Section 75 Modification

Commercial Building C3 (Mod 3) - MP11_0044

Barangaroo South

March 2015 ■ 10051

Figure 1 – Approved and Proposed Podium Footprint

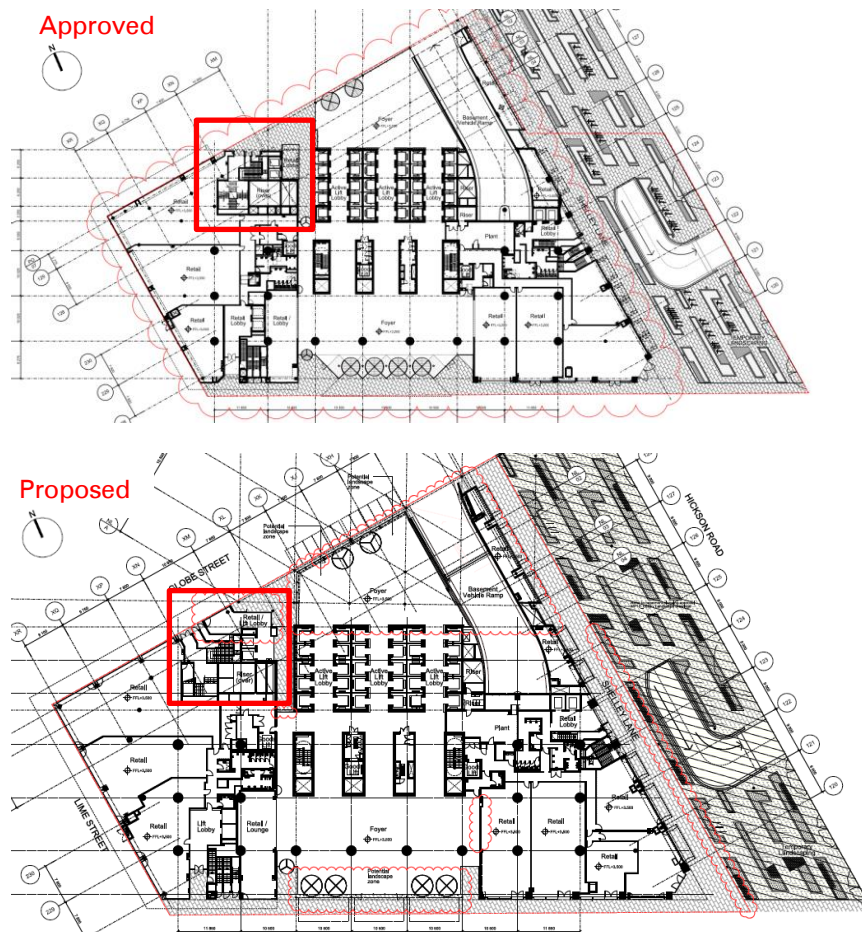
It is proposed to extend the approved podium level to provide better integration with the north lobby. The western lobby will be extended to the north east. The extension will include additions to all three podium levels and include an extension of the approved awning on the northern elevation. The proposed modification is shown in **Figure 1**.

Figure 8 – Removal of PV Cells

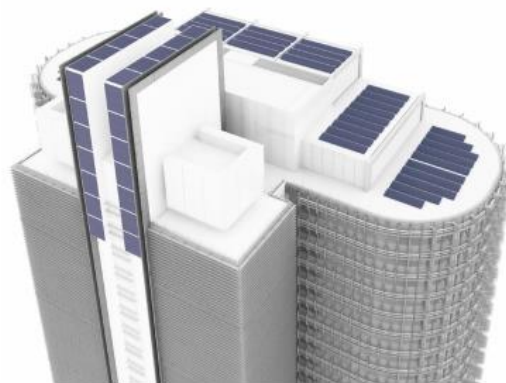
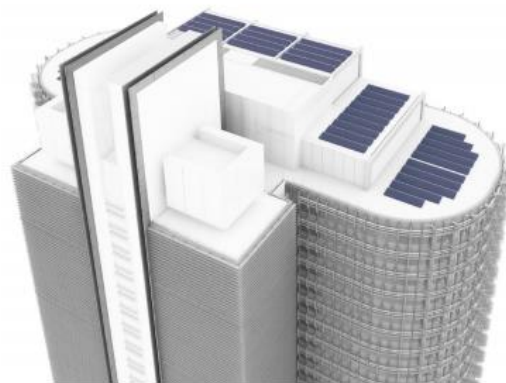
The Approved Project features PV cells on the tower core as well as the tower roof. In order to simplify the complex integration of the north core PVs coupled with yield, quantum and value discussions, these core PV are intended to be removed as shown in **Figure 8**. This proposed modification will not diminish the ability of the building to meet the stated ESD requirements.
